MODEL
2014-2018MY
Soul (PS)
2012-2017MY
Rio (UB)
2014-2017MY
Forte (YD, YDm)

NUMBER
038 (Rev 1, 06/11/2019)

TECHNICAL SERVICE BULLETIN

AIR DRAIN CASE REPLACEMENT

Air Drain Case
(YD & YDm)

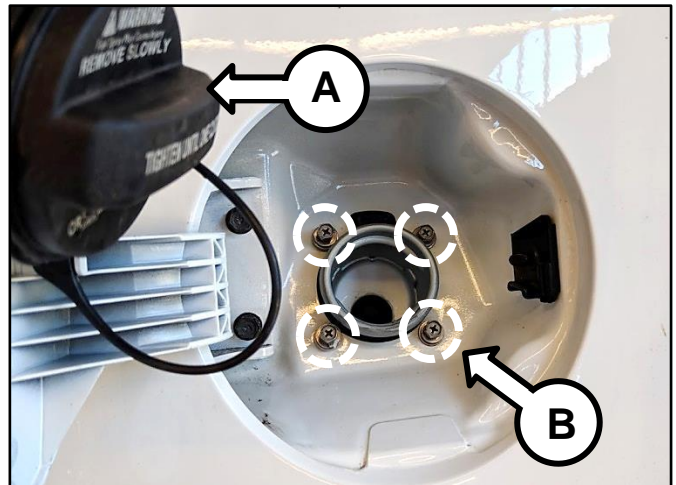
This bulletin provides the procedure to replace the **Air Drain Case** on some 2014-2018MY Soul (PS), produced from July 21, 2013 through June 1, 2017, some 2012-2017MY Rio (UB), produced from June 21, 2011 through March 31, 2017, some 2014-2017MY Forte (YD), produced from February 18, 2013 through March 2, 2017, and some 2017MY Forte (YDm) vehicles, produced from May 16, 2016 through March 6, 2017, which may experience an early shut-off during fuel refill and/or a Malfunction Indicator Lamp (MIL) illumination with DTC(s) **P0449** (Evaporative Emission System – Vent Valve / Solenoid Circuit) or **P0451** (Evaporative Emission Control System Pressure Sensor Range/Performance) Do NOT replace the CCV for these two listed DTC codes. Follow the procedure outlined in this bulletin to **replace the Air Drain Case**.

Canister Close Valve replacement is not required to repair this condition. Failure to follow proper procedure may result in a dealer chargeback.

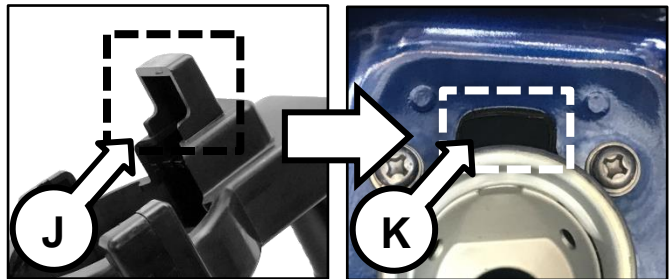
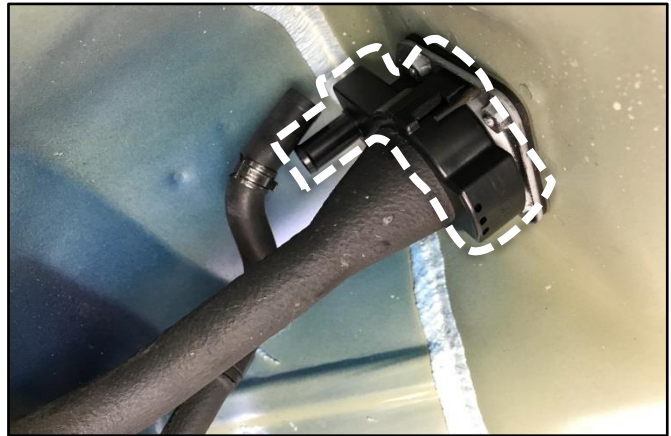
- 5a. **Forte (YD) and (YDm):** Install the new improved fuel filler neck air drain case in the reverse order of removal. Ensure the vent of the Air Drain Case (J) is inserted properly through the opening (K) and ensure a click is heard when installing the new air drain case assembly.

Ensure the outer air drain case half is installed in the correct orientation with the contacts aligned and not upside down.

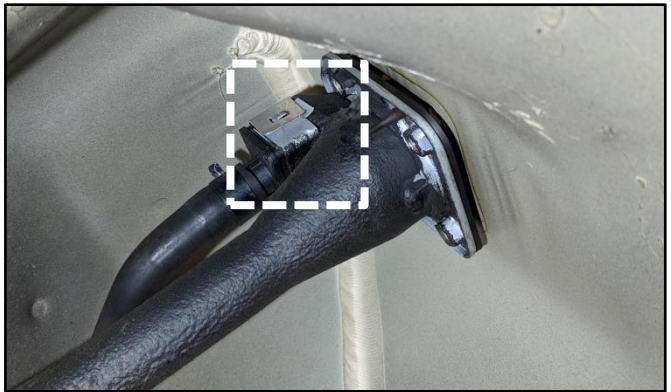
- 5b. **Soul (PS) and Rio (UB):** Install the new improved fuel filler neck Air Drain Case in the same reverse order of removal. Ensure the vent of the Air Drain Case (J) is inserted properly through the opening (K) and ensure a click is heard when installing the retaining bracket.
